Specification Comparison

TDK PRODUCT NAME: DC/AC INVERTER UNIT CXA-0547

CTR-3911-X

The difference between CXA-0349 and CXA-0547.

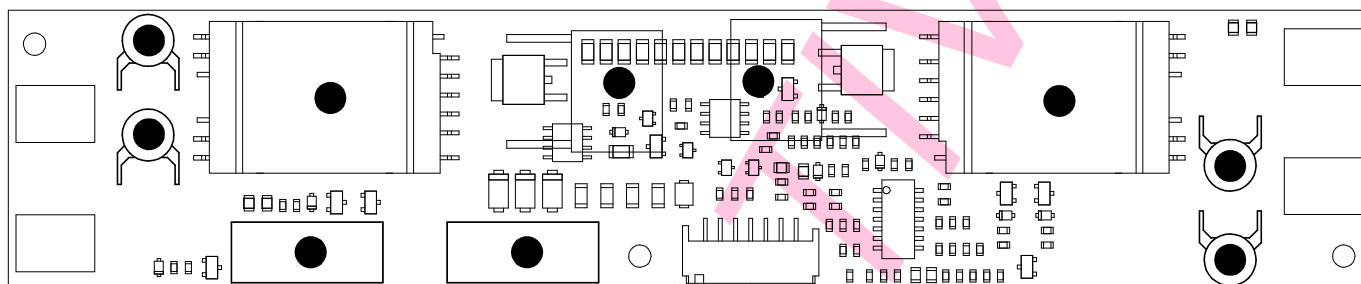
Input fuse rating is changed because the lamp impedance at low temperature is high.

1-1.Appearance

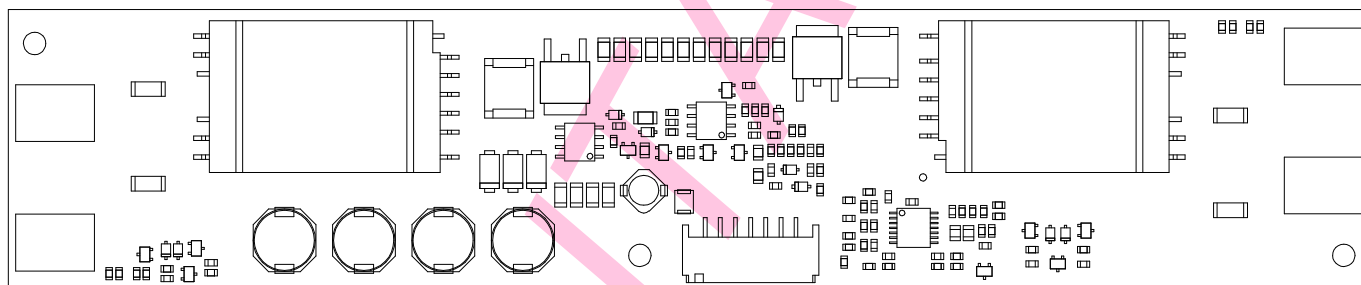
The appearance of CXA-0547 is changed as follows because several component is changed from CXA-0349.

The CXA-0349 has several hand mount components indicated in ●.

All of components are mounted by machine in CXA-0547.
